PERMIT

SEWAGE DISPOSAL SYSTEM

HOWARD COUNTY
BUREAU OF ENVIRONMENTAL HEALTH
992-2330

ADDRESS 8214 Reservoir Road, Fulton, MD 20759

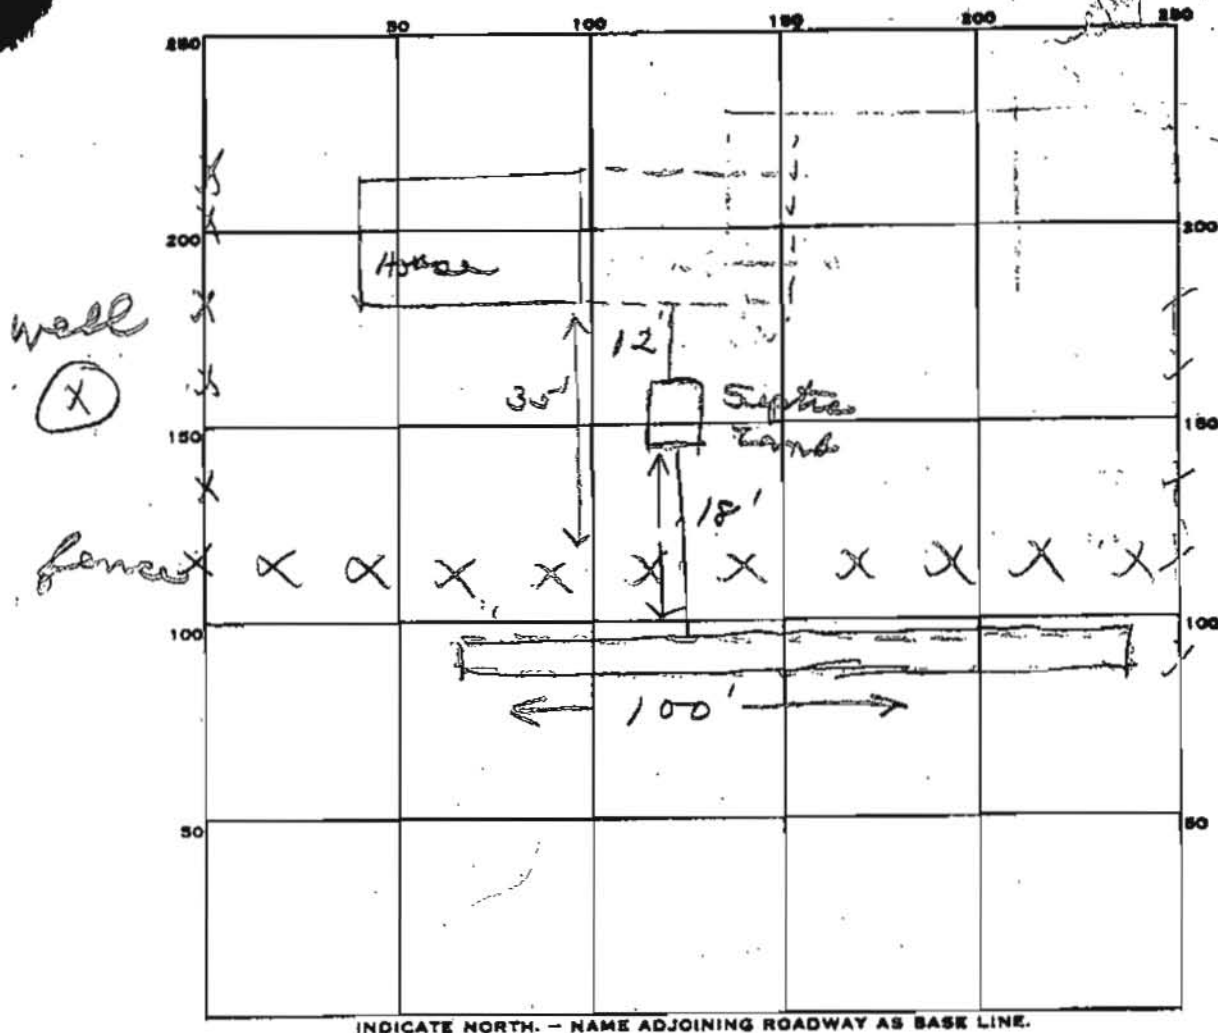
REPAIR. 5/9/83 Discussed moving septic at least 10 ft from any part of bldg. ~~Tracing to see present disposal with~~
~~septic tank location~~. Will call for appointment later for installing trench & inspect new septic tank location.

5/10/83 New septic tank & trench system req'd to S.

5/17/83 Trench - 100' long, 12' deep, with 7' of stone -

REMARKS 5/17/83 - 13 ft gravel dug - good soil, minor, and silt
6/16/83 OK to add stone in trench fs
6/16/83 OK to cover all work fs

EH - 24

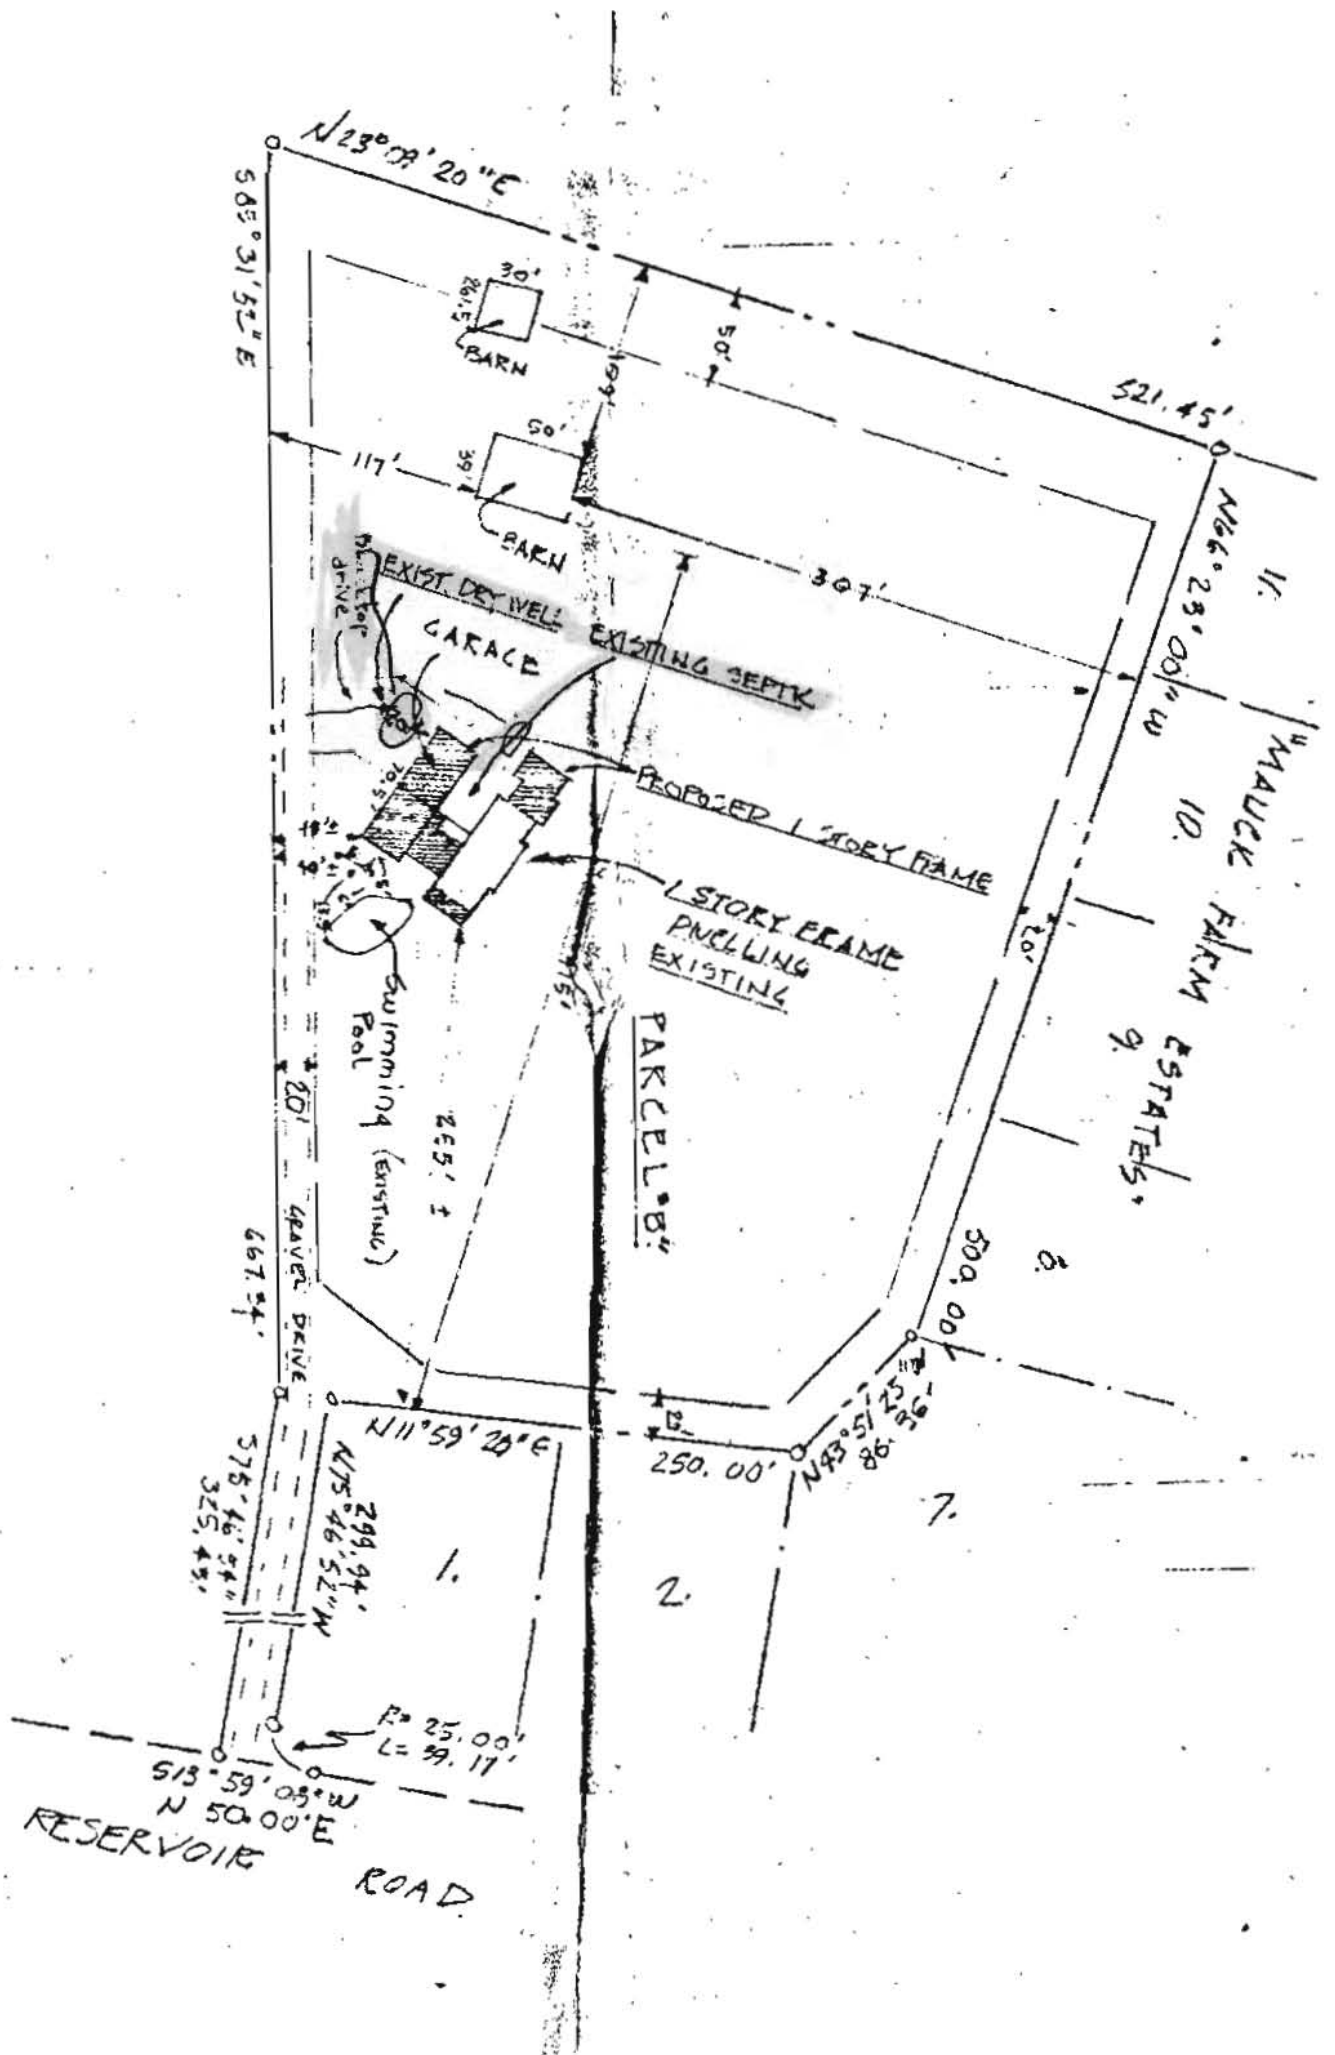
ITEM NO.	QUANTITY ORDERED	QUAN. SHIP	ITEM DESCRIPTION	UNIT COST	UNIT SELL	SELL AMOUNT
5/10/83			Existing House			
5/10/83			Existing 1000 Gal Tank			
5/10/83			Proposed Man Hole 2'			
5/10/83			Existing 8" opening			
5/10/83			Proposed 3 Can Garage			
5/10/83			Replace Existing Fiber Pipe with Cast-Iron			
5/10/83			Replace Existing 4" C.P. with 6" Cast Iron w/ Brass Plug			
5/10/83			Existing Dry Well
